STAFF REPORT ADDENDUM

RZ/FDP 2001-PR-050

APPLICANT: Stanley-Martin Homebuilding, LLC

PROPOSAL: Rezone the subject site from R-1 and HC to PDH-12 and HC for the development of 43 single-family attached dwellings

CONCEPTUAL/FINAL DEVELOPMENT PLAN

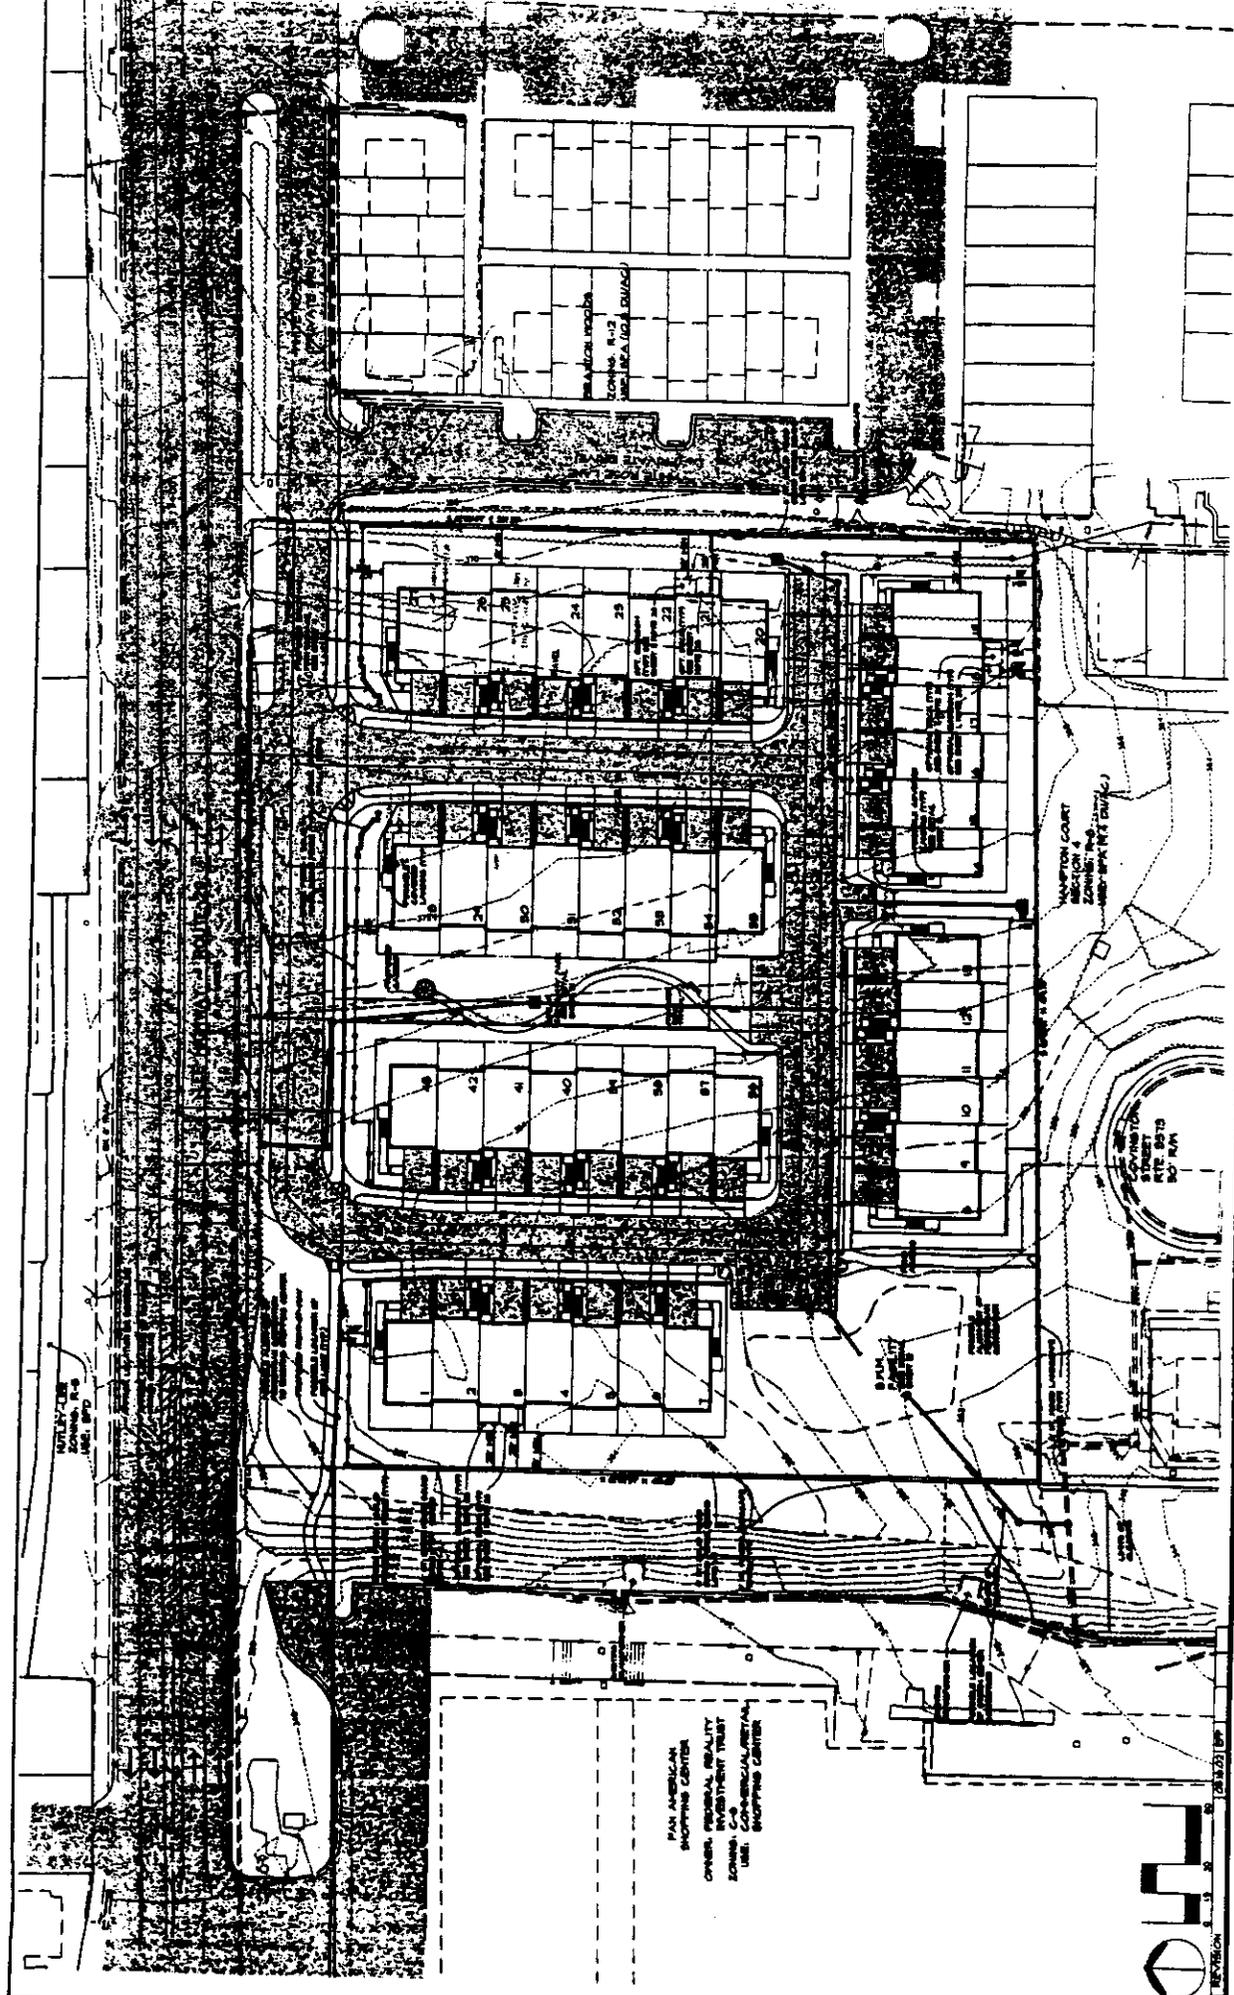
Second, the applicant has increased the distance between the optional sunroom and the southern and eastern periphery of the site from 20 to 25 feet. The applicant has proposed this increase in distance in order to address staff's concern about the impact that the proposed three (3) story sunroom additions may have on the abutting residences to the south and east. However, staff does not believe that the additional setback of five feet addresses the additional bulk created by the sunrooms. Even with the minimum setback of 25 feet, staff believes that the sunrooms will continue to adversely impact the abutting residences. Therefore, staff continues to recommend a development condition which would limit the height of the sunrooms to two stories in height along the southern and eastern property lines.

ARCHITECTURAL ELEVATIONS

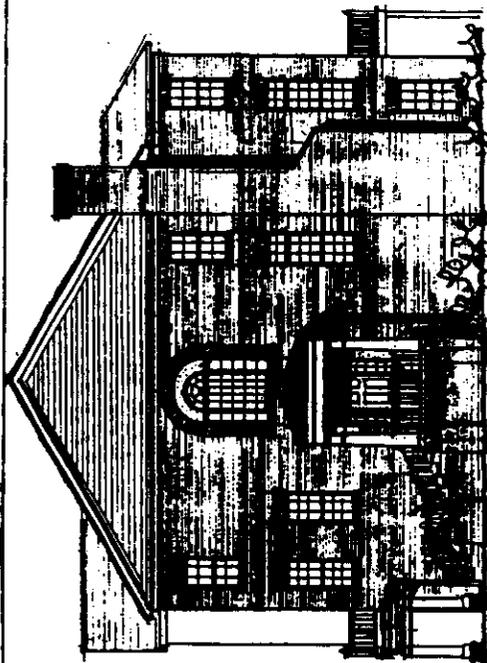
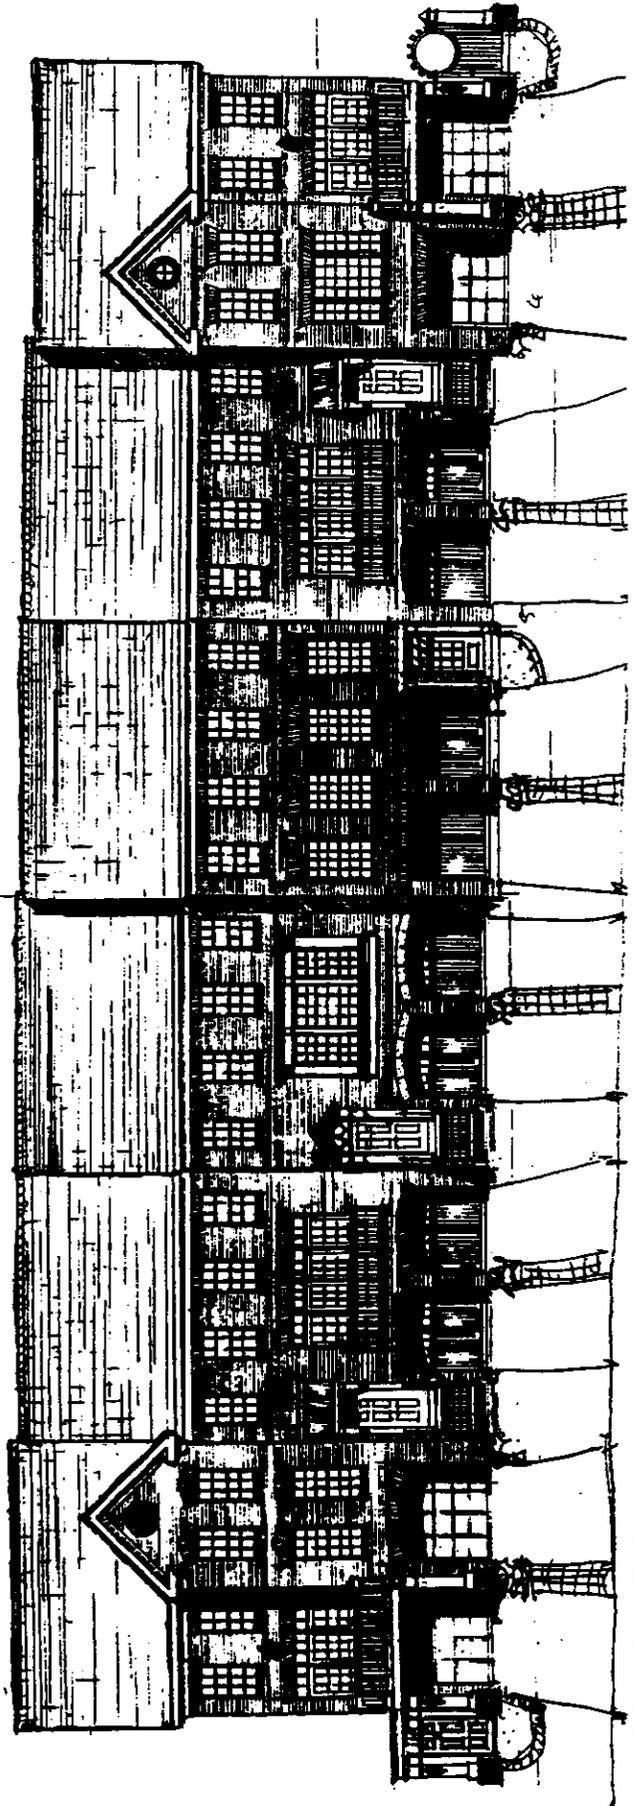
The applicant has submitted a revised Conceptual/Final Development Plan (CDP/FDP), as revised through May 16, 2002. A copy of the revised CDP/FDP is included at the front of this addendum. The revised plan contains two changes. First, new architectural elevations has been included on Sheet 6. These elevations depict a new front elevation, as well as the right side elevation of the units along Lee Highway with the optional sunroom.
